Rebuild of the Libby (FEC) to Troy Section of
Bonneville Power Administration's
Libby to Bonners Ferry 115-kilovolt Transmission Line Project

Final Environmental Impact Statement

May 2008

The Final EIS includes additions, changes, and deletions (shown in red) to the EIS text since publication of the Draft EIS. The comments received on the Draft EIS and responses to the comments are in Chapter 9. Additional appendices have been added to respond to comments and summarize information. A listing of the general changes in each chapter is listed on the next page.

Figure 2-2. Typical Suspension Structure Types

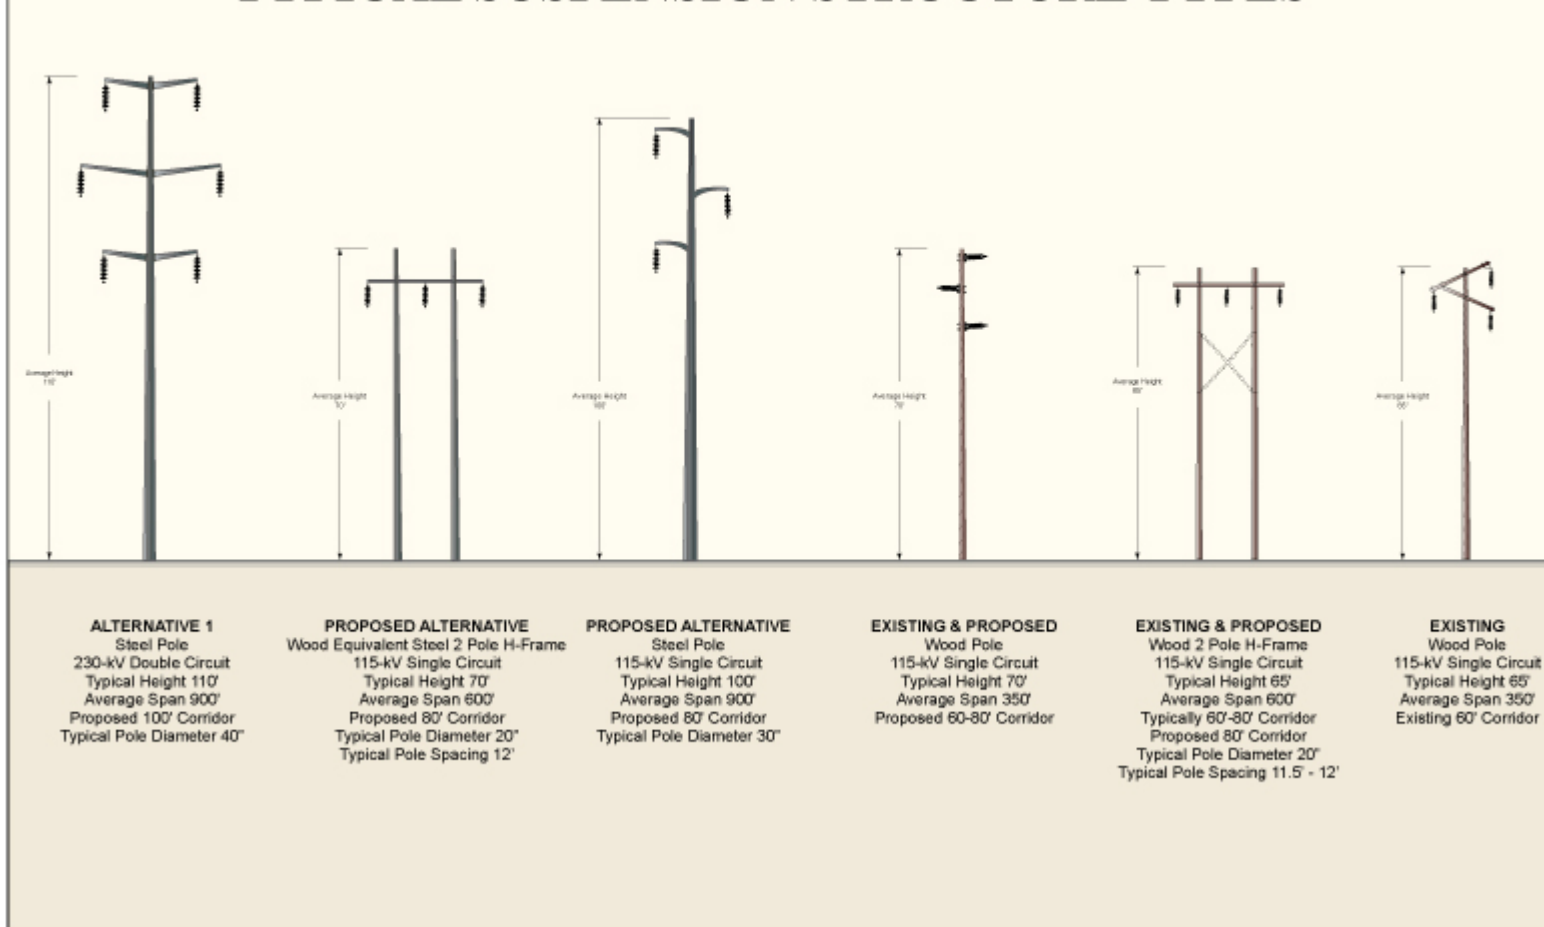
Comment: *Figure S-2 gives information about types of structures including height, span length and proposed corridor width. What are the base dimensions for each structure type? [LTD - 0013]*
